TRANS/WP.29/923
17 April 2003

World Forum for Harmonization of Vehicle Regulations (WP.29)

DRAFT SUPPLEMENT 3 TO REGULATION No. 112

(Headlamps emitting an asymmetrical passing beam)

"Annex 4 - Appendix 1

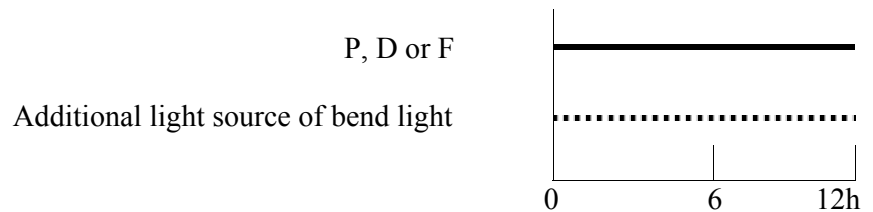
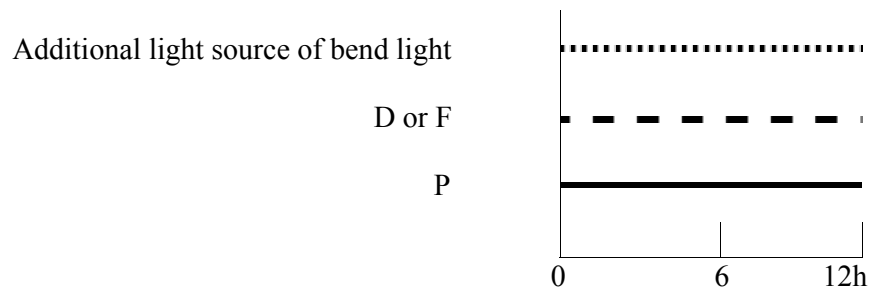
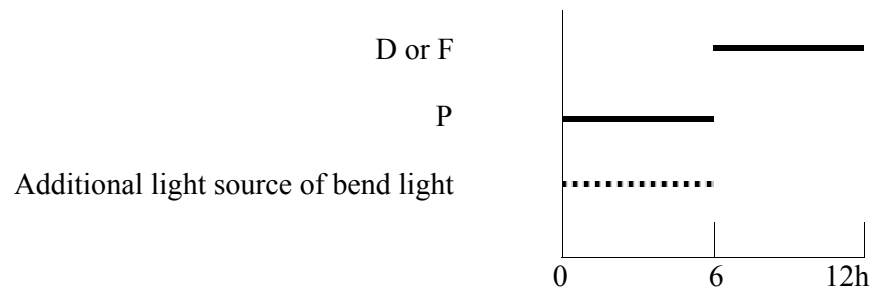
Annex 4, paragraph 1.1.1.1., add a new subparagraph (d) to read:

- "(d) In the case of a passing beam designed to provide bend lighting with the addition of a light source, this light source shall be switched on for 1 minute, and switched off for 9 minutes during the activation of the passing beam only (see annex 4 - appendix 1)."

Insert new Annex 4 - appendix 1, to read:
